August 25, 2020

**Subject:** 100 Altair Way – Avian Collision Risk Assessment and Documentation of Compliance with City of Sunnyvale Bird-Safe Design Guidelines (HTH #4375-01)

Figure 2. The extent of bird-safe glazing treatment to be incorporated on the east (left) and west (right) facades of the building is outlined in purple.

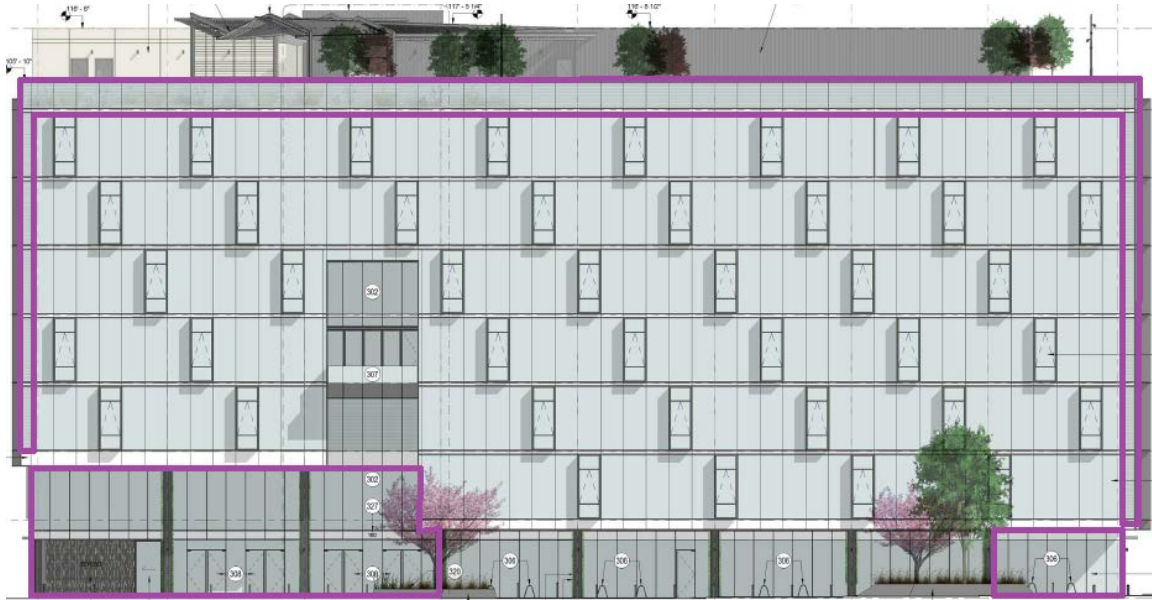
The project will incorporate bird-safe glazing with a visible or UV frit pattern on certain portions of the building to reduce the frequency of bird collisions with glazed facades. The type of bird-safe glazing and frit pattern may vary for different areas of the facades, but all vertical elements of the window patterns will be at least 1/4-inch wide at a minimum spacing of 4 inches, and horizontal elements be at least 1/8-inch wide at a minimum spacing of 2 inches to ensure that the pattern minimizes bird collisions with the glazing. The extent of the proposed bird-safe glazing treatment on the building's facades is shown on Figures 2 and 3.

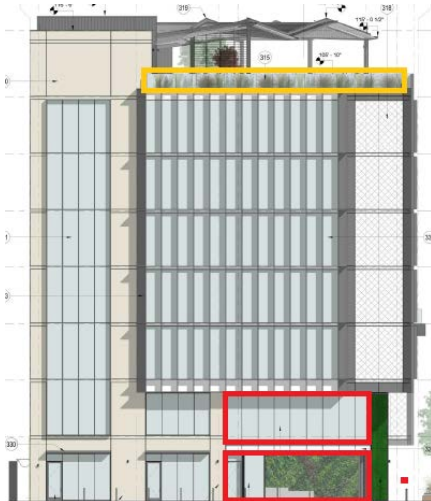
No glass skyways are included in the project design; however, a free-standing glass “fin” is proposed along the margins of the building’s north façade (Figure 6) and free-standing glass railings are proposed along the periphery of the building’s roof on the east, west, and north facades and at the Level 4 balcony on the north facade (Figures 8–10).

To reduce the potential for bird collisions with free-standing glass, all free-standing glass that is located along a potential flight path for birds (i.e., adjacent to or surrounding areas with landscape vegetation) shall be treated with a bird-safe treatment that will increase the visibility of this glazing to birds by allowing them to perceive the glass as a solid surface (i.e., all glazing on the free-standing glass "fin" along the margins of the building's north façade, all free-standing glass railings along the periphery of the building's roof, and the free-standing glass panel at the lobby entrance should be treated. In our opinion, the free-standing glass railing located at the Level 4 balcony does not need to be treated because no landscape vegetation is proposed at this location, and thus the railing is not located along a potential flight path for birds such that birds would be expected to collide with glazing at this balcony.

- All glazing on the free-standing glass railings surrounding the green roof.
- All glazing on the free-standing glass "fin" along the margins of the building's north façade.
- All glazing at the lobby entrance (i.e., on Level 1 at the building's northeast corner) and on Level 1 at the building's northwest corner

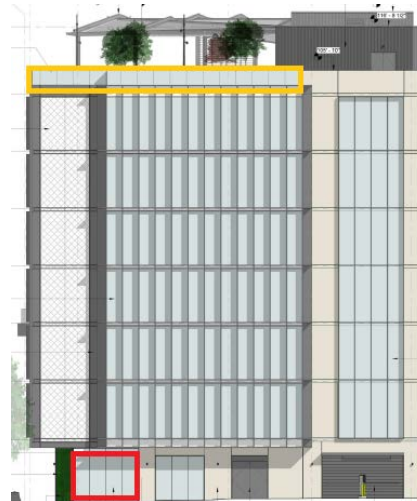
**Figure 9.** The east façade of the 100 Altair building. A free-standing glass railing is present along the periphery of the roof and a free-standing glass panel is present on Level 1 (shown in orange), posing collision hazards to birds. Transparent glass corners that are located along potential flight paths for birds, and hence represent potential collision hazards, are shown in red. In our opinion, these areas should be treated with a bird-safe glazing treatment to comply with the City's guidelines.
